MIL-F-63230 (AR)
AMENDMENT 2
8 SEPTEMBER 1983
SUPERSEDING
AMENDMENT 1
16 March 1981

MILITARY SPECIFICATION

FUZE, PIBD, XM740, SECOND ENVIRONMENT SENSOR FOR

This amendment forms a part of Military Specification MIL-F-63230 (AR) dated 17 August 1979, and is approved for use by the U.S. Army Armament, Munitions and Chemical Command and is available for use by all Departments and Agencies of the Department of Defense.

Figure 1 - Direction of Applied Acceleration

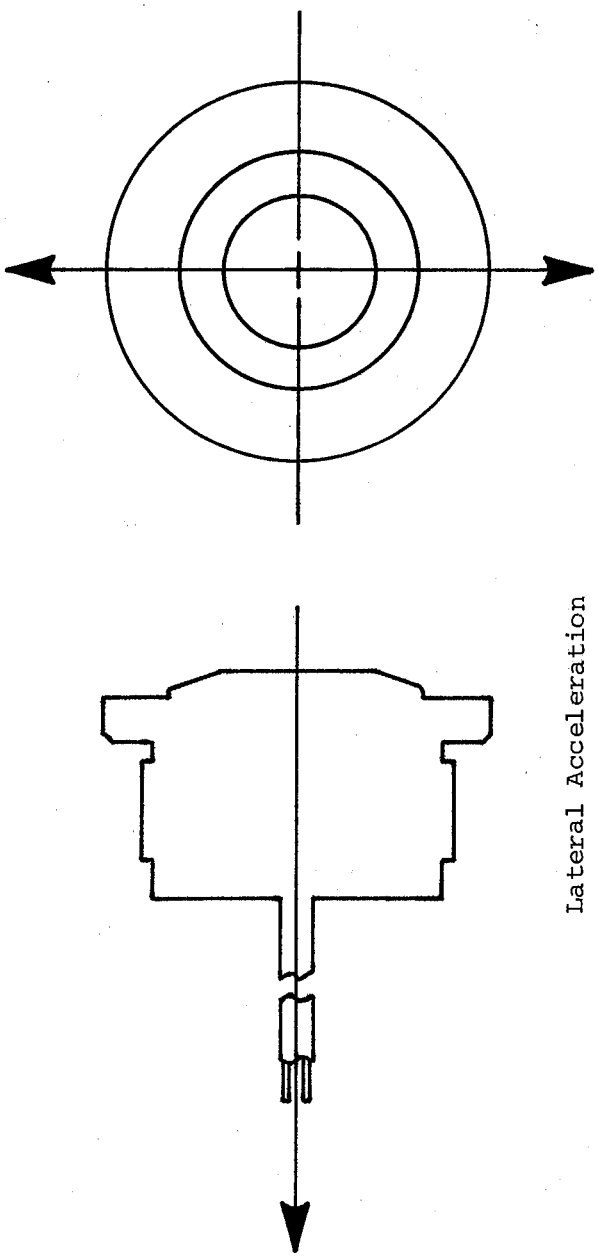
* Figure 1: Delete in its entirety and substitute the attached Figure 1.
